PA0060038

**NPDES PERMIT FACT SHEET
INDIVIDUAL SEWAGE**

**Julia Ribaudo Healthcare Group, LLC
DBA Julia Ribaudo Extended Care
Center DBA Saber Healthcare Group**

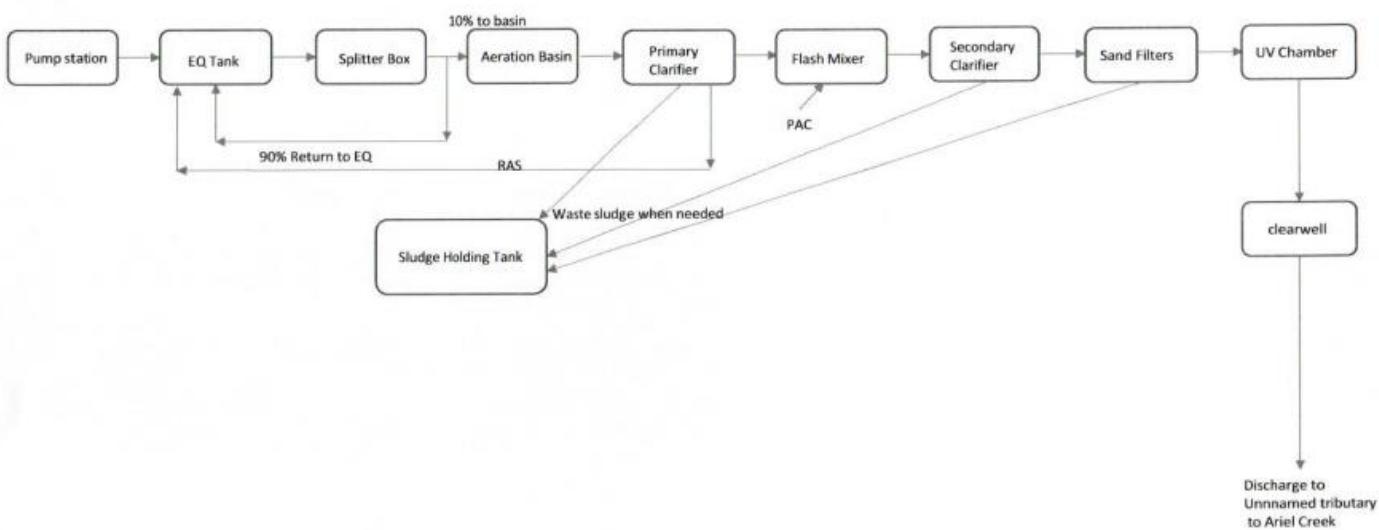
Changes Since Last Permit Issuance: See 2023 EPA Compliance Inspection Report comments below for current conditions:

- **Observation 2:** Facility representatives stated during the inspection that this process flow diagram is outdated with portions of the plant no longer in operation. The portions of the plant no longer in operation included: the sand filters (Photos DSCN3956, DSCN3957), secondary clarifier (Photo DSCN3949), and flash mixing tank (Photo DSCN3948) as noted in the diagram. Facility representatives mentioned that Farnham and Associates, the Facility's engineering company, is responsible for updating the process flow diagram and fact sheet.
- **Observation 3:** The EPA Inspection Team noticed that there was algal & solids built up at the trough and weir of the clarifier (Photos DSCN3943 – DSCN3944). The treated effluent appeared clear with a well settled sludge blanket on the bottom.

- The EPA Inspection Team walked to the settling tank from the clarifier. In the past, this area was utilized as a secondary clarifier and flash mixing tank. Presently, it contains no mixing or chemical dosing and is utilized for solids settling before UV disinfection. During the inspection, the EPA Inspection Team observed how the settled solids transferred to the wasted sludge reservoir. A manual sump pump transfers the sludge to a wasted sludge reservoir. Once the sump pump turned on, it appeared that it stirred the settled sludge up to the surface, turning the liquid cloudy (Photo DSCN3952). The increase in turbidity may affect UV-disinfection in the next step of the treatment train.

- The EPA Inspection Team observed the sand filters that have been inoperable for years (Photos DSCN3956 – DSCN3957). EPA asked Facility Representatives if the filters had ever been cleaned out after the final use. Facility representatives replied that it was once pumped out and taken apart, however the sand filters have been out of operation in the same location for at least 30 years. It is unclear if there is a plan to remove them from the treatment process or restore them back to proper operable conditions. The Facility stated that it would be costly to disconnect them from the treatment system.

- **Observation 4:** The programmable logic controller (PLC) screen did not display power readouts of the UV chamber at the time of inspection (Photo DSCN3970). It was unclear how long it has been out of operation or if it would be fixed. Facility representatives stated that it normally operates at 2.0 mW/cm².

- The EPA Inspection Team travelled to the location offsite designated by coordinates on the Permit as the location for Outfall 001, but were not able to locate nor access the outfall due to the outfall's location on private property and a lack of outfall signage (Photos DSCN3971 – DSCN3972).
